ADDENDUM NO. 4

**Chattanooga Public Library
HVAC and Electrical Renovations, Phase Two
City Contract No. L-19-001-201
Chattanooga, Tennessee**

Date: 30 Oct 2019

Sheet E-103 Electrical Third Floor

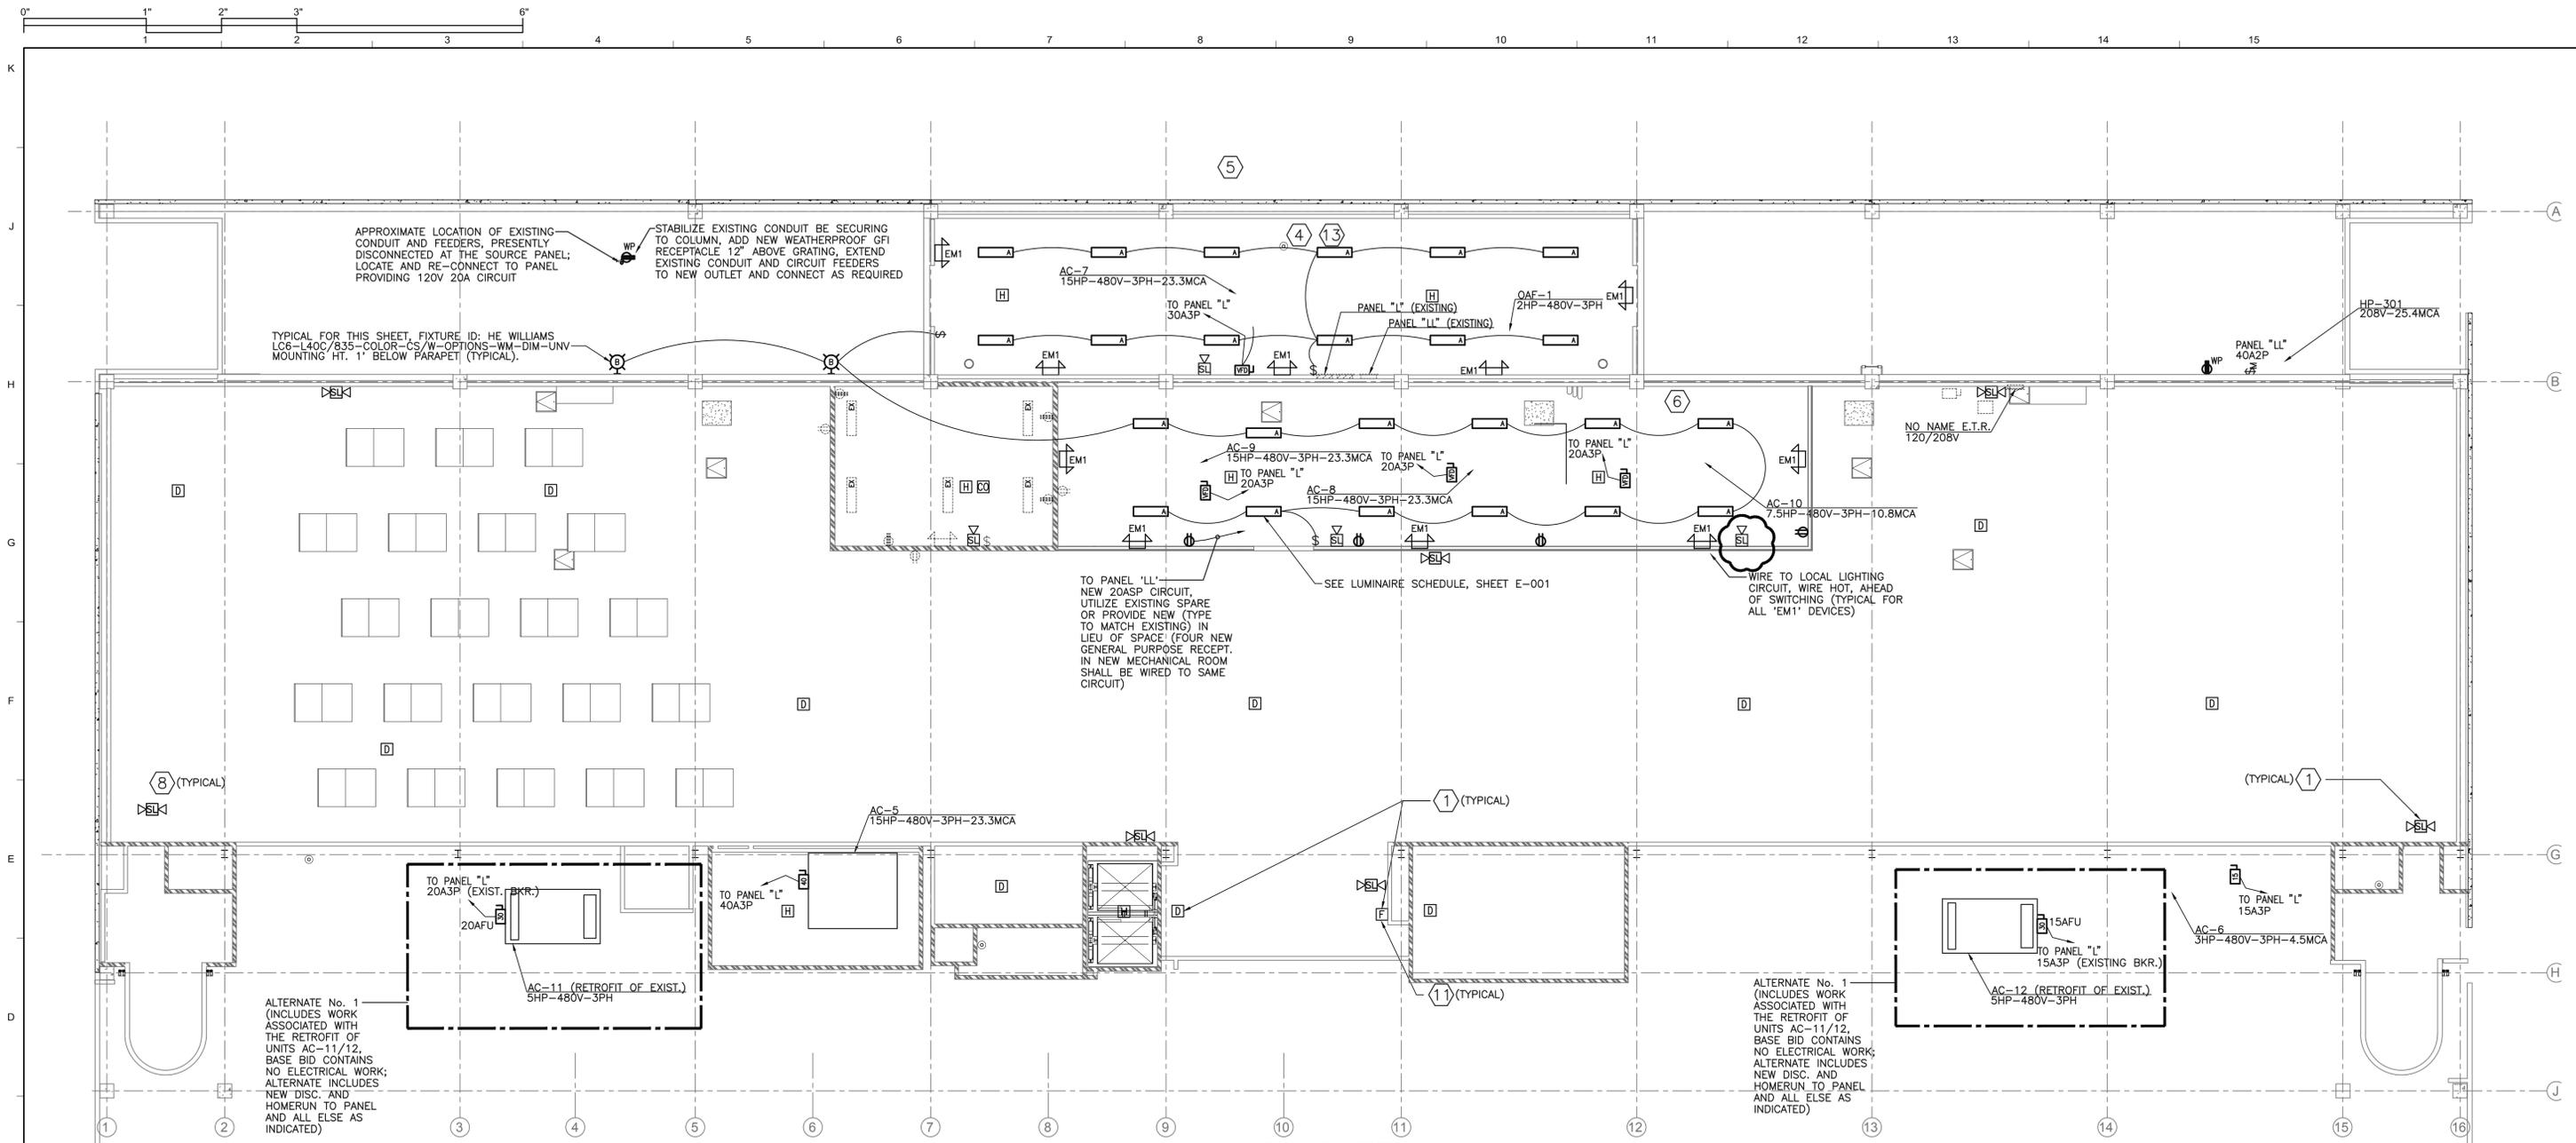
MINI UNITS ARE TO BE SERVED BY COMMON 208V-1PH 20ASP CIRCUIT BREAKER FROM PANEL "HH", HOMERUN TO PANEL & UTILIZE SPARE OR PROVIDE NEW BREAKER AS REQUIRED (TYPICAL OF 5)

- ⑤ ALL VAV'S FURNISHED W/ 12V/24V STEP DOWN BY MECH, INSTALLED/WIRED ELECTRICAL CONTRACTOR. E.C. SHALL PROVIDE NEW 120V/20A CIRCUIT FED FROM NEAREST AVAILABLE 120/208V PANEL. CIRCUIT MAY BE SHARED WITH MULTIPLE VAV LOCATIONS ON SAME FLOOR ONLY (MAX 1800VA PER 20A CKT). ON THIS FLOOR UTILIZE PANEL "HH" FOR VAV'S EAST PORTION (UTILIZE SPARE 20ASP BREAKER FROM DEMO TO MATCH EXISTING), AND "KK" FOR WEST.

Existing Fire Alarm Cabling Plan

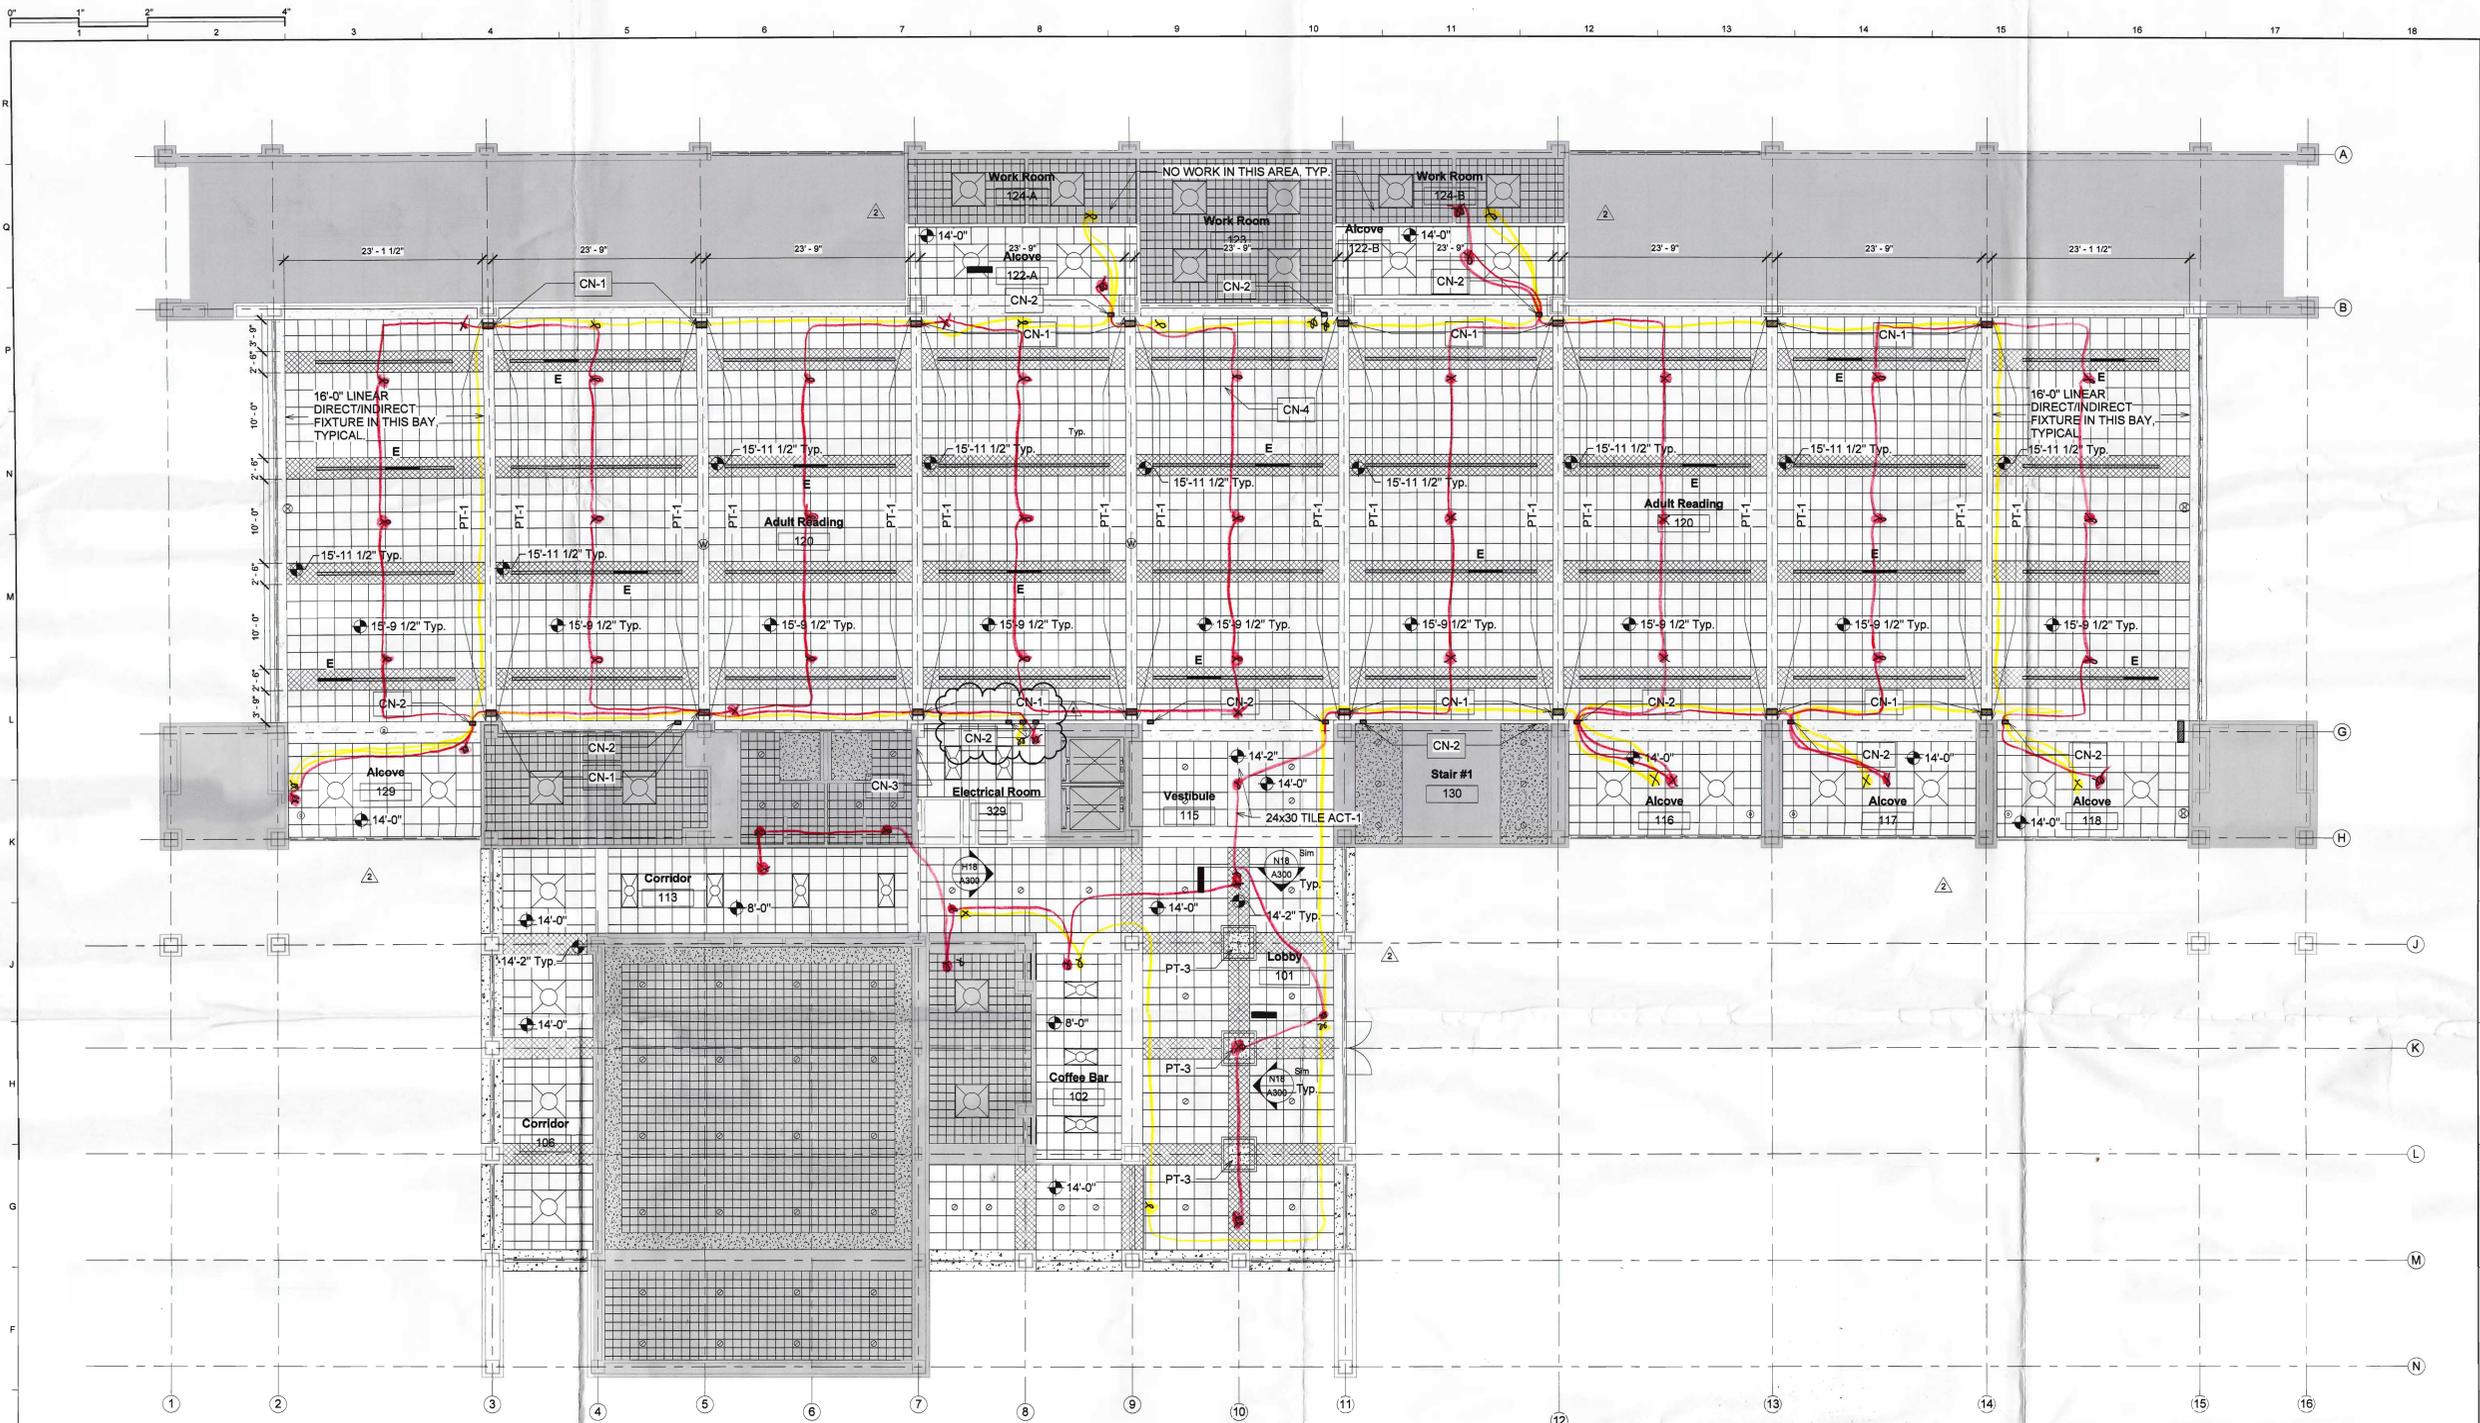
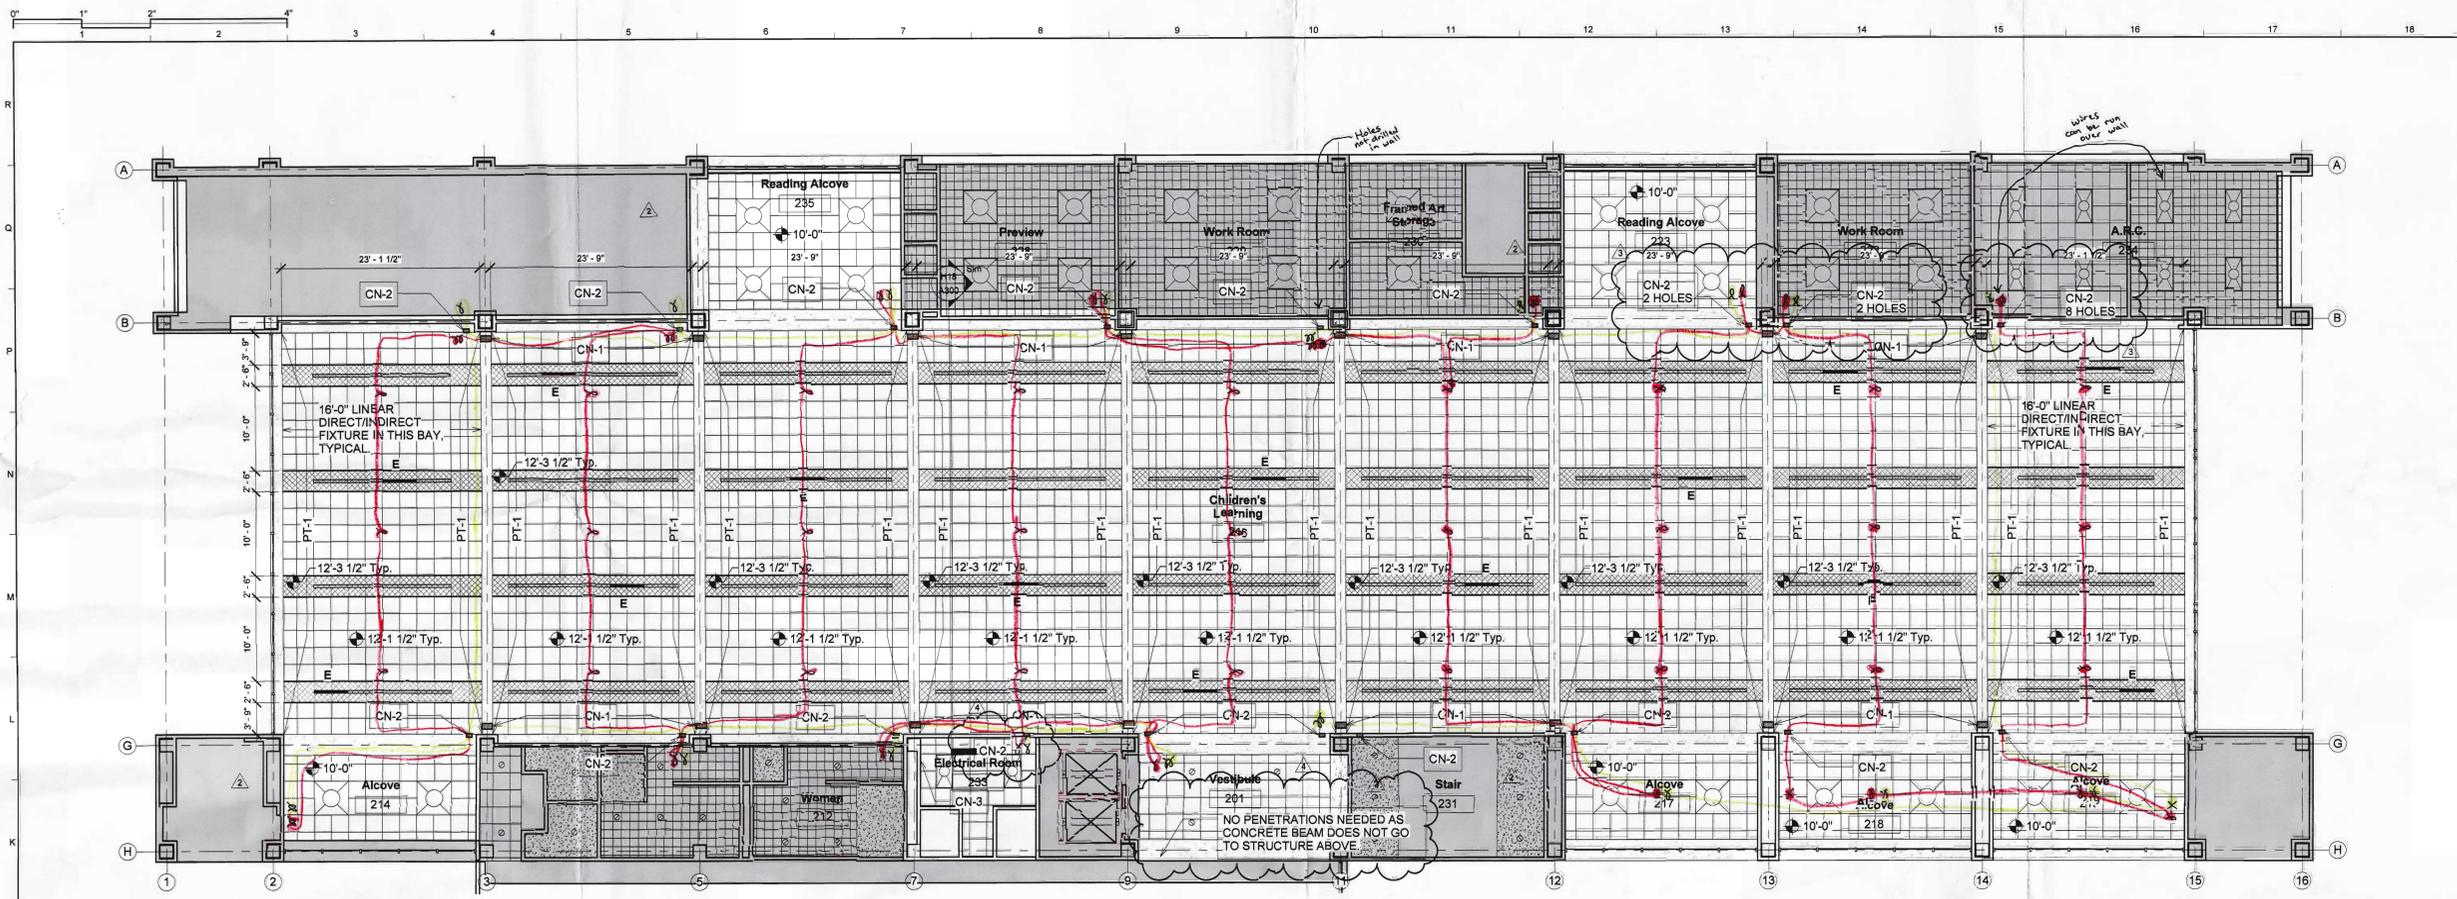
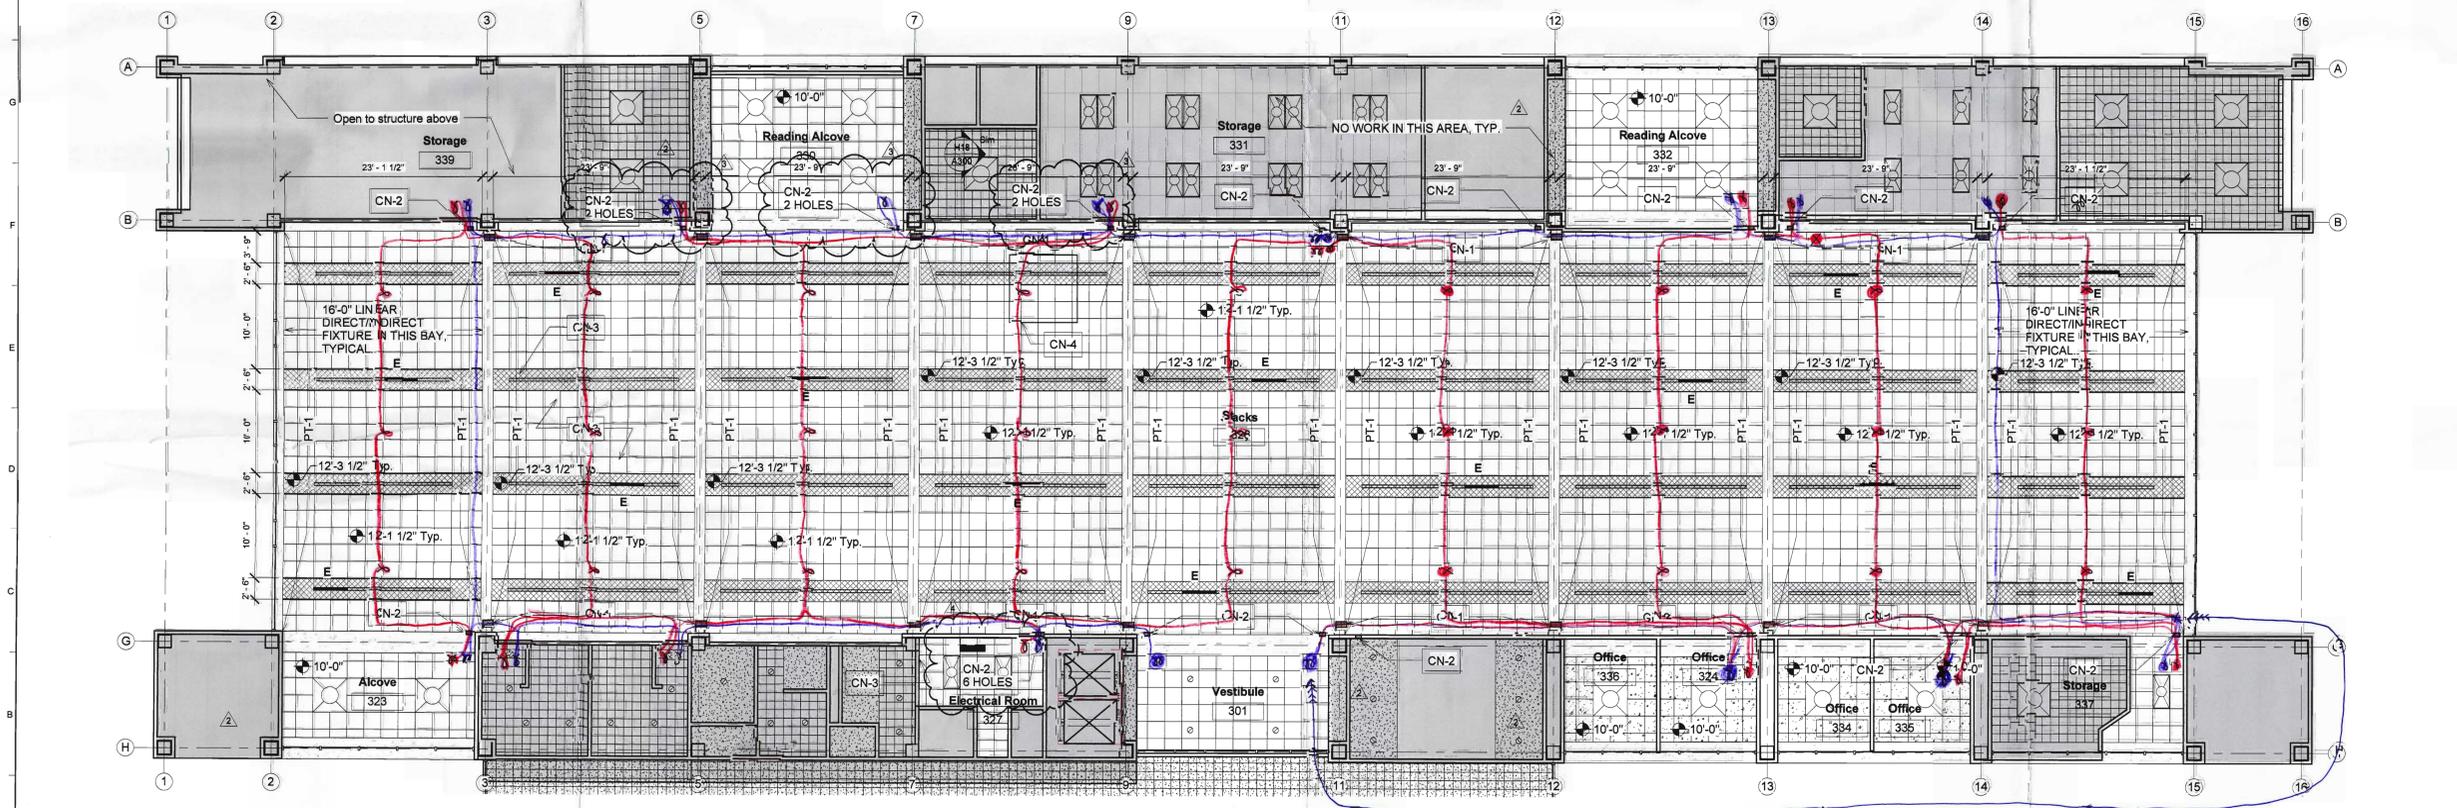
Two drawings are attached that indicate the approximate location of fire alarm cabling currently installed for the Contractor's use. This is the extent of know cabling. All additional cabling shall be provided as part of this work.
